GRADING & DRAINAGE PLAN

SUMMARY OF REVISION FOR POND REQUIREMENTS

BANDELIER FLWS & PHASE-II SHELL
3015, 3019 OSUNA BLVD N.E. ALBUQUERQUE, N.MEX.

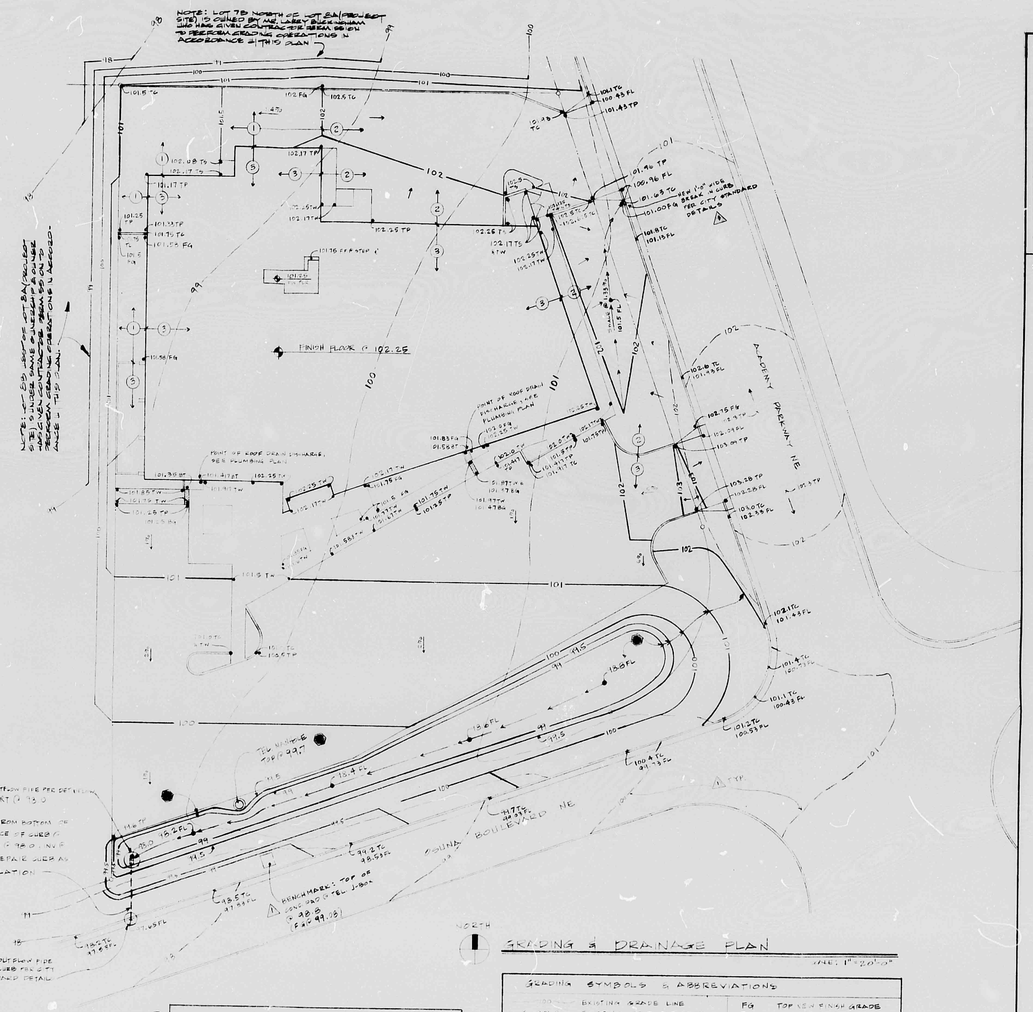
(2) LANDSCAPING OF PONDING AREA RESULTED IN A REDUCTION OF PLANNED PONDING CAPACITY.

(3) EXCESS OVERFLOW ALONG SOUTHERN BANK OF POND @ 105 CONTOUR // ESTABLISHED LANDSCAPING PROVIDING EROSION-FREE SPILLWAY

I have reviewed the above "As-built" Grading Plan as per Revision No. 2, dated 5/5/82, and hereby approve the Plan in relation to the existing Telephone Manhole located at the northern perimeter of the ponding area.

no.	date	revision
	5-5-82	ADDED TELEPHONE MANHOLE TO PLAN. REVISED PONDING AREA GRADES TO EXIST. "AS-BUILT" CONDITIONS. ADDED TEL CO APPROVAL BLOCK
1	7-18-81	REVISED GRADES IN S. SIDE POND TO ELIMINATE PONDING IN CITY R.O.W., REVISED VOL. CALC'S PER ABOVE SUMMARY, REVISED STREET TOPO LINES, REVISED BENCHMARK, ADDED DETAILS, ATTACHED LETTER RE: AREA 1 RUNOFF & BLDG FIN FLR

1. Contributing Area 3 =
   .814 acre = 35,458 sq. ft.
2. Ponding Volume Required:
   $V_{required}$ = (.1)(35,458) = 3546 cu. ft.
3. Ponding Volume Provided:
   $V_{provided}$ = 1815 sq. ft. x 1.5' depth
   + $\frac{461' \times 1.5 \times 4.5}{2}$ = 4278 cu. ft.
4. Quantity of run-off per outflow pipe calculation in Drainage Report:
   Q = less than 1.26 CFS

"As-built" Ponding Volume Provided:
Vol = 2543 SF x 1' avg. depth +
$\frac{425' \text{ perimeter} \times 0.5' \times 2.5'}{2}$ = 2809 cu. ft.
